Technical Service Bulletin Notification TSB #18-006
Unit Serial Number:

Jayco has determined that certain Model Year 2019 Aspire, Anthem, Cornerstone, and Insignia Class A motorhomes require installation of a new dash relay to address intermittent AC controls.

TSB # 18-006

FIG 1: Stand at the driver side of the generator slide.

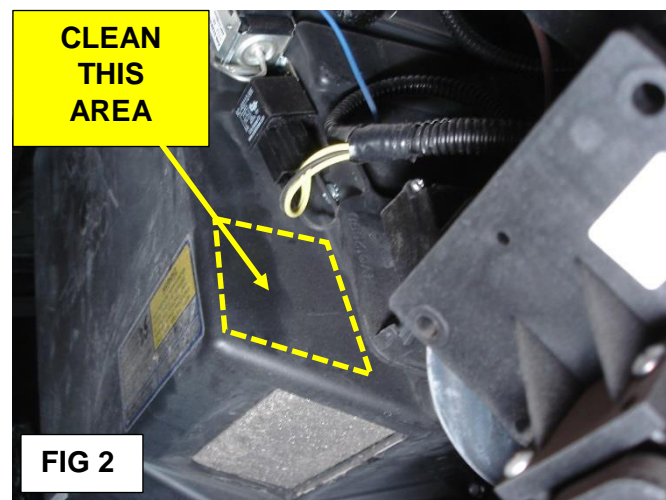
Crouch down so you can see up inside the front of the vehicle.

The relay is mounted to the black plastic case for the evap/heater core assembly.

It will be directly in front of you up above the generator slightly.

FIG 2: The harness should be unplugged from the old relay (not shown in this photo).

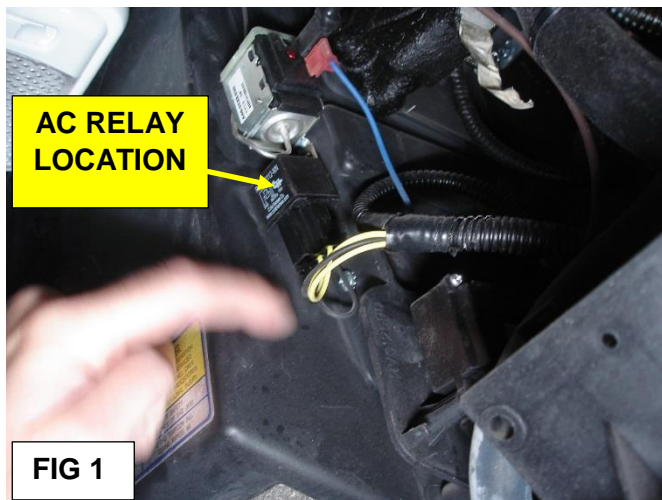
Use isopropyl alcohol and the clean rag and clean the plastic case in dashed area shown.
